**PETITION FOR CHANGE OF THE PROJECT DESCRIPTION IN THE FINAL
DECISION TO INSTALL AND OPERATE AN EMERGENCY ENGINE**

PALOMAR ENERGY CENTER

(O1-AFC-24C)

MAY 2010

CRITICAL POWER PROJECT
SITE PLAN

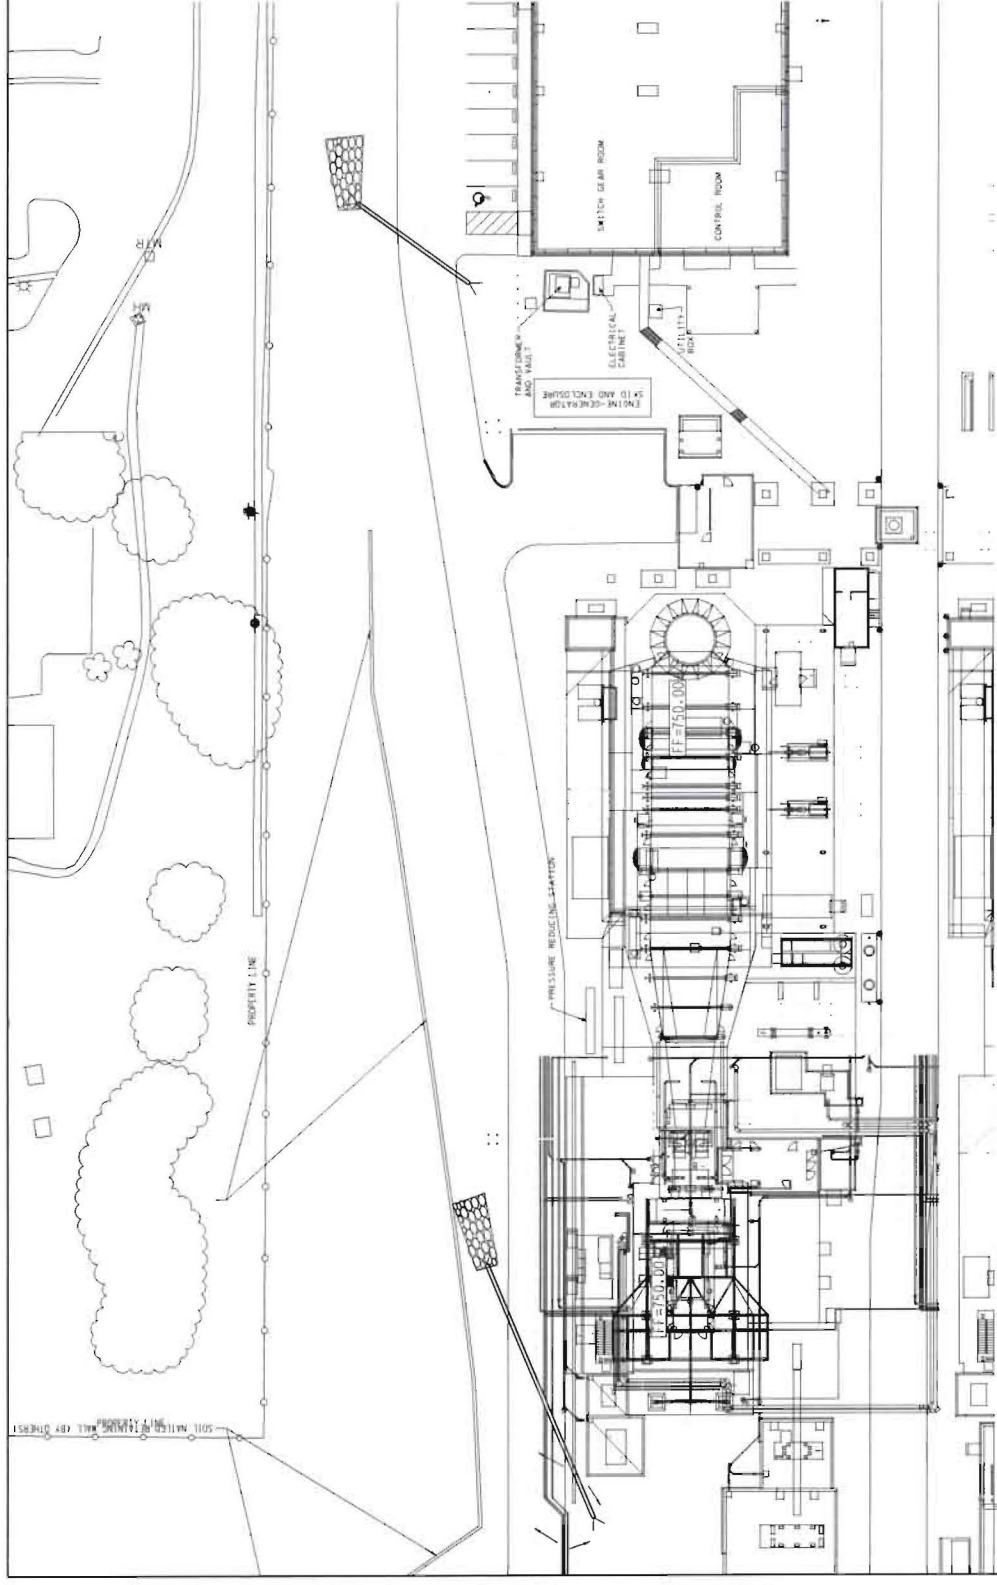
The facilities will be designed to have minimal visual impact and will meet surface treatment requirements condition of certification VIS-3. Paint color will match the current plant structure paint color as approved by the Compliance Project Manager. Neither structure will exceed the height of adjacent buildings. For additional details see Appendix 2 for site plans and Appendix 3 for a visual rendering. Additional site plans are included in the application to the SDAPCD.
